Access Compliance Report

Public Rights-of-Way

(Curb Ramps)

Intersection ID: 9565	Main Street: N_TRYON_ST	Cross Street: W_32ND_ST	Location: SE
ADA ID: FF9C36906DE3	Ramp Type: PerpDiag	Initial Pass/Fail: Fail	Overall Compliance: No
Severity Score: 12.5			
Codes/Mitigation Info/Possible Solution		Field Measurements/Component Compliance

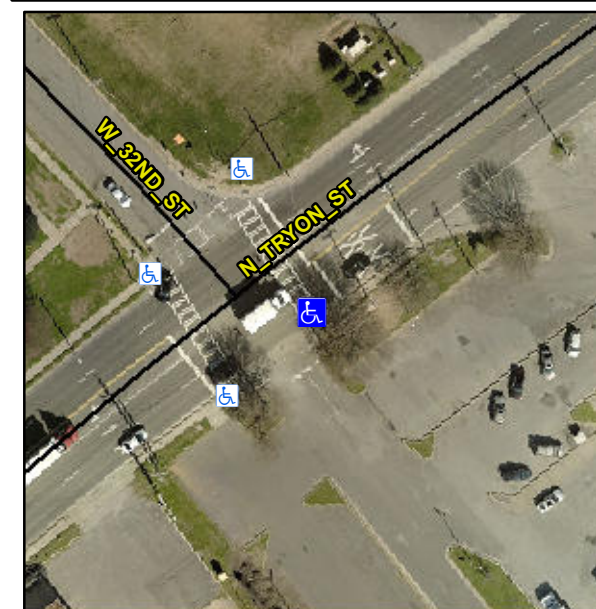
Not Found, R304.2.2

Compliance	Description	Data	Compliance	Description	Data
N/A	Ramp Length (in)	58.5	No	Ramp Slope (%)	11.2
Yes	Ramp Width (in)	51.0	Yes	Ramp XSlope (%)	0.2
N/A	Flare Type LT	N/A	N/A	Flare Type RT	N/A
N/A	Flare Slope LT (%)	N/A	N/A	Flare Slope RT (%)	N/A
N/A	Flare Traversable LT?	N/A	N/A	Flare Traversable RT?	N/A
N/A	Landing Length (in)	N/A	N/A	DWS Provided?	N/A
N/A	Landing Width (in)	N/A	N/A	DWS Contrast?	N/A
N/A	Landing Slope (%)	N/A	N/A	DWS Length (in)	N/A
N/A	Landing X Slope (%)	N/A	N/A	DWS Full Width?	N/A
N/A	Landing Curb? (Y/N)	N/A	N/A	DWS Offset (in)	N/A
N/A	Shared Landing?	N/A			
N/A	Gutter Ponding?	N/A	N/A	Gutter Slope (%)	N/A
N/A	Gutter Lip Ht (in)	N/A	N/A	Gutter X Slope (%)	N/A
N/A	Painted X Walk1?	No	N/A	Painted X Walk2?	No
	X Walk 1 Direction	To NE		X Walk 2 Direction	To SW
N/A	X Walk 1 Width (in)	N/A	N/A	X Walk 2 Width (in)	N/A
	X Walk 1 Slope (%)	3.7		X Walk 2 Slope (%)	0.2
	X Walk 1 X Slope (%)	0.7		X Walk 2 X Slope (%)	1.8

Remove & Replace Curb Ramp With Two New Directional Ramps or Equivalent.
